BASS RANCH MASTER DEVELOPMENT PLAN

City of San Antonio
Planning Department
Master Development Plan Section
APPLICATION

TO:	Ernest Brown, Planner II
FROM:	Junaid Malik, E.I.T.
COPIES TO:	Michael Herrera, Sam Dent, P.E., Richard Carrizales, Rick Wood, P.E., File
SUBJECT:	Bass Ranch MDP <i>Cibolo Creek Watershed</i>

The City Staff Development Review Committee has reviewed Bass Ranch Subdivision Master Development Plan M.D.P. # 823. Please find enclosed a signed copy for your files. Your plan was accepted, however please note the following:

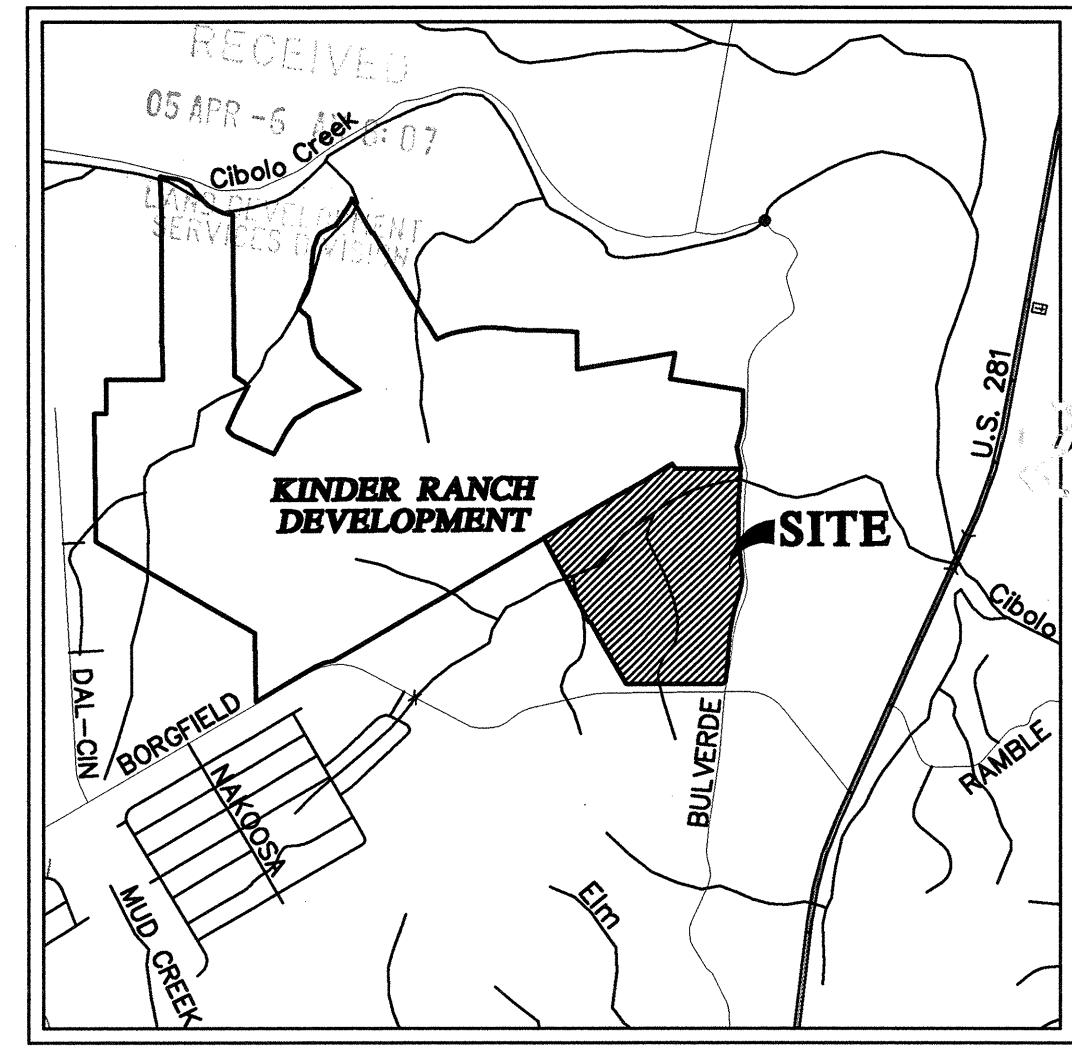
Comments: BULLYERDE ROAD IS ON THE MTP REQUIRING A MIN. OF 80' ROW
BORGFELD ROAD IS ON THE MTP REQUIRING A MIN. OF 80' ROW. PROPOSED MDP
ADDRESSES THOROUGHFARE. PROPOSED PLAN NEED TO ADDRESS 35-506(e)(2) PROJECTION
OF ROADS INTO UNPLATTED AREA TO THE WEST; 35-8101, TWO POINTS OF ID BY TX.
PLANE COORDINATES, APPROXIMATE LOCATION OF STREETS, SCHEMATIC LOCATION OF
STREETS (RIN 4.012). REMOVE NOTE Q AND DATE INDICATION - THIS IS NOT
A PUO PLAN OF ENCLAVE; IF NO DETAIL AND OR STREET LAYOUT ON PLAN A SUPPLEMENTAL
IS REQUIRED TO ASSES CONNECTIVITY RATIO 35-506(e)(1) →

35-506(c) Hierarchy of roadways; Flood plain will be platted on every lot
Tract 1, 2, 3, & 4 be noted on plan; eliminate PUO NOTE References.
Provide legend indicating limit lines, property lines etc.

BASS RANCH
MASTER DEVELOPMENT PLAN

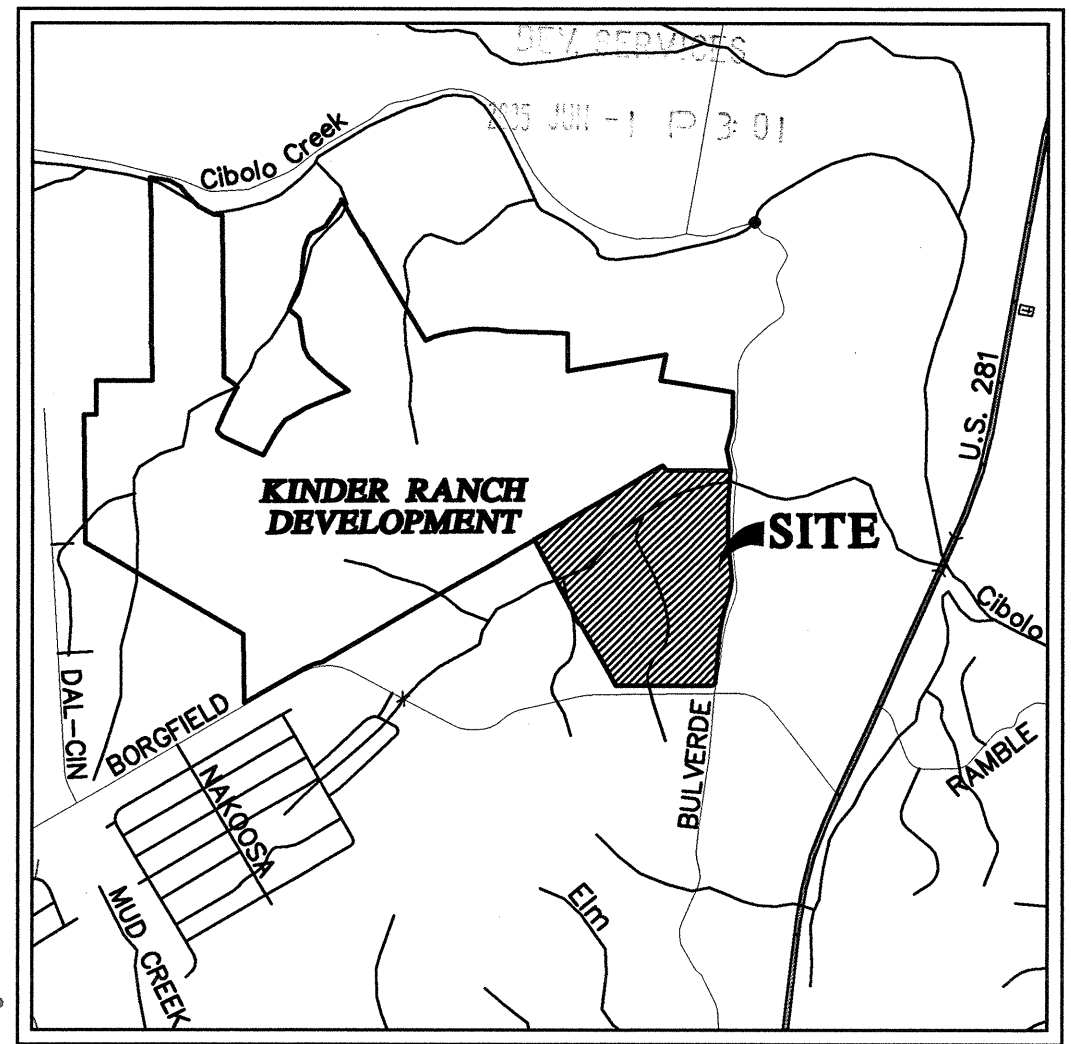
1. Based on the comments below this MDP cannot be released.
2. Since the submittal did not provide drainage study on the Cibolo Creek floodplain, please provide signature of owner and engineer on the MDP with the following note.

"The floodplain limits on this Master Development Plan are estimated and subject to change. Approval of subdivision plats associated with this Master Development Plan is subject to the review and approval of Storm Water Management Plan in accordance with Appendix B, Section 35-B119 of the City of San Antonio Unified Development Code."

THE FLOODPLAIN LIMITS ON THIS MASTER DEVELOPMENT PLAN ARE ESTIMATED AND SUBJECT TO CHANGE. APPROVAL OF SUBDIVISION PLATS ASSOCIATED WITH THIS MASTER DEVELOPMENT PLAN IS SUBJECT TO THE REVIEW AND APPROVAL OF A STORM WATER MANAGEMENT PLAN IN ACCORDANCE WITH APPENDIX B, SECTION 35-B119 OF THE CITY OF SAN ANTONIO UNIFIED DEVELOPMENT CODE.

TYPICAL STREET SECTION 50' ROW
LOCAL TYPE "A"
(NOT TO SCALE)
*28" PAVEMENT UNLESS NOTED OTHERWISE

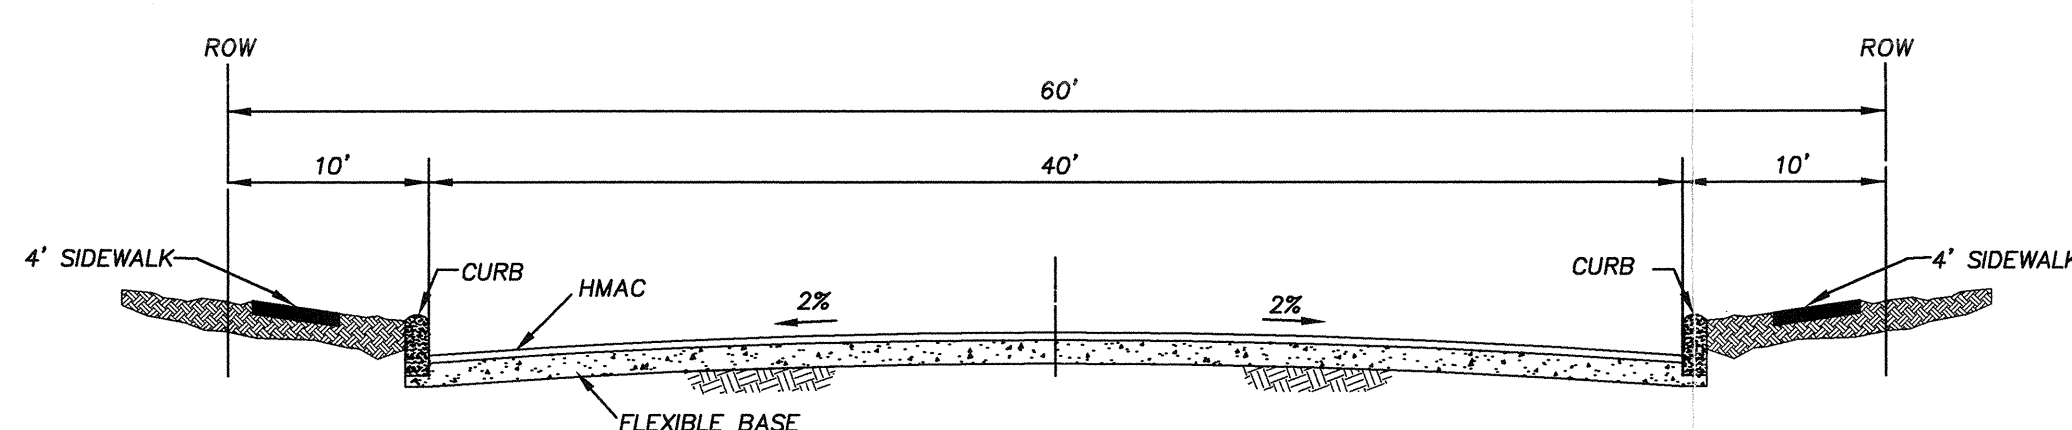
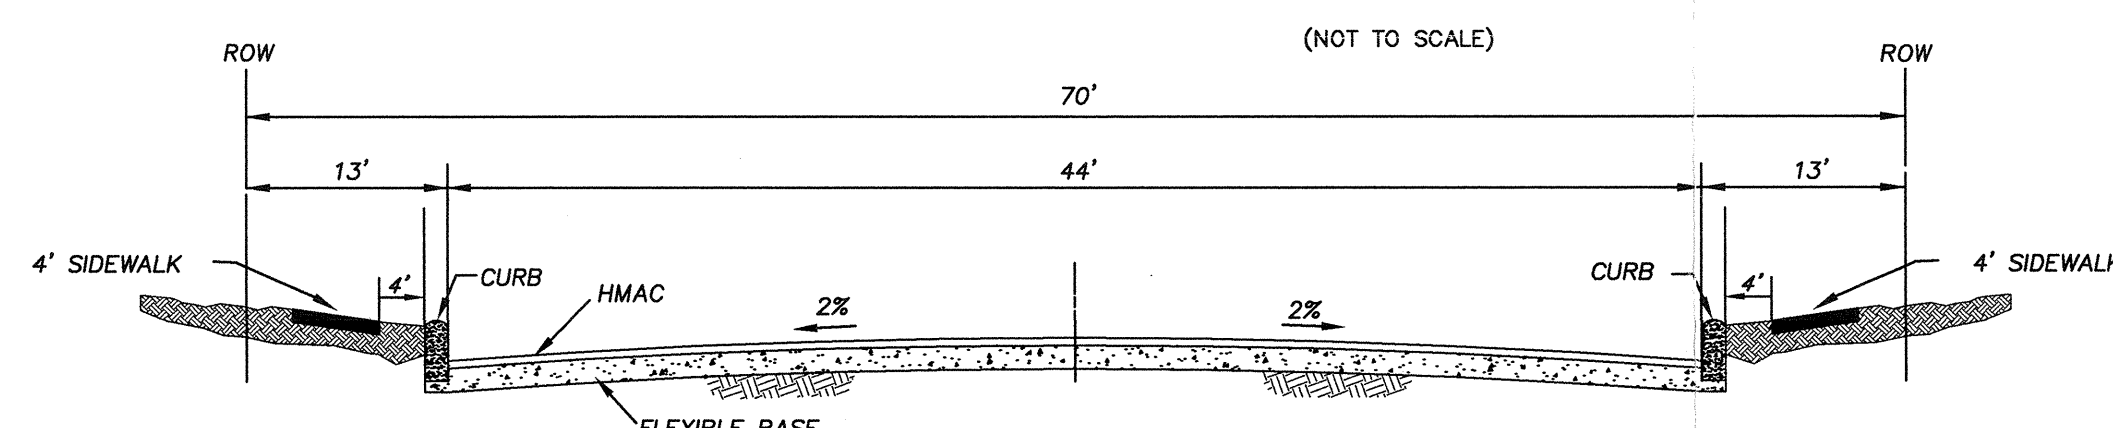
- **Bulverde Road** - The Developer shall dedicate 43 feet of ROW (Ordinance 98282, October 2, 2003 Major Thoroughfare Plan (MTP)) from the centerline of Bulverde Road (Secondary Arterial Type A – Uniform Development Code (UDC) 35-506, (g), (2)) adjacent to this proposed project. The total length of property frontage is approximately 3200-feet.

- **East Borgefeld Drive** - The Developer shall dedicate 43 feet of ROW (Ordinance 98282, October 2, 2003 Major Thoroughfare Plan (MTP)) from the centerline of Borgefeld Drive (Secondary Arterial Type A – Uniform Development Code (UDC) 35-506, (g), (2)) adjacent to this proposed project. The total length of property frontage is approximately 1500-feet.
